Office Action Summary	Application No. 10/621,062	Applicant(s) STECK, RICKY B.	
	Examiner William H. Rodriguez	Art Unit 3746

DETAILED ACTION***Claim Rejections - 35 USC § 102***

2. Claim 33 is rejected under 35 U.S.C. 102(b) as being anticipated by **Green et al.** (US 4,303,088).

Green teaches a valve comprising: a shuttle member for controlling air flow; and a detent mechanism for controlling movement “oscillation” of the shuttle member. See particularly **Figure 1** of Green.

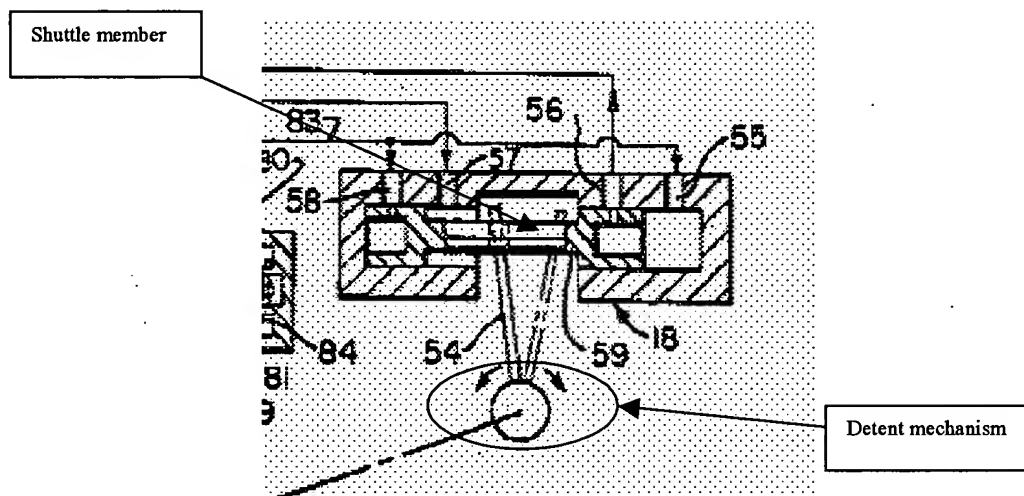
limitations recited in claim 33 are: a valve that has a valve member “shuttle member” and a mechanism “detent mechanism” that moves said valve member. These are inherent features of any typical valve which comprises a valve member that moves back and forth to open an inlet or close an outlet, which must inherently comprise some mechanism to move said valve member from the open position to the closed position and vice versa. For instance, one example is below.

With regards to the intended use recitation “the detent mechanism permitting a user to change the rate of oscillation of the shuttle member such that the need for additional valves or controllers for regulating the rate of oscillation is eliminated”. A recitation with respect to the manner in which a claimed apparatus is intended to be employed does not differentiate the claimed apparatus from a prior art apparatus satisfying the structural limitations of the claims, as is the case here.
